Service Bulletin

PRELIMINARY INFORMATION

Subject: Shorter Front Bumper Fascia Air Deflector Available for Service

Models: 2011-2013 Chevrolet Volt

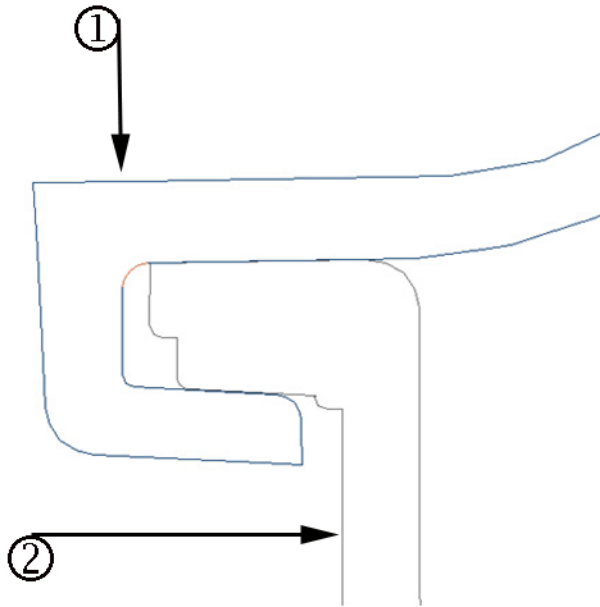
1. The two screws shown above are preinstalled at the plant and need to be removed from the wheelhouse liner prior to air deflector installation. Reinstall these screws first when installing the air deflector.

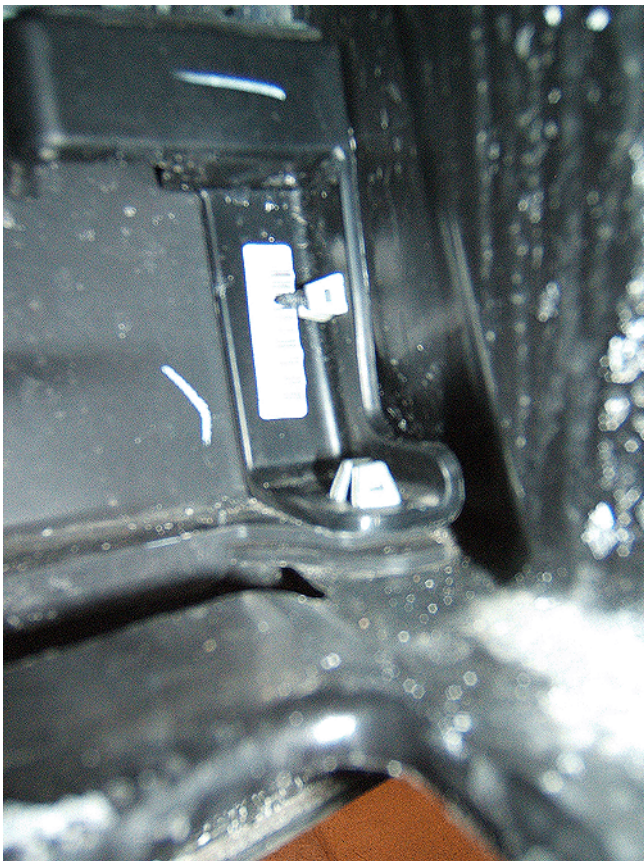
2. The air deflector (2) needs to be fully seated into the "C" channel on the lower fascia (1) as part of the assembly. Insertion into the "C" channel is a tight fit.
3. Prior to installing the screws, line up all three pieces of the air dam to the fascia first.

Important: When installing the screws, verify all holes line up and that the screw catches the retaining nut.

4. Working from the center section of the assembly helps eliminate any possible bowing when installing the remaining screws.

Important: The "C" channel must be fully inserted to ensure a quality fit.
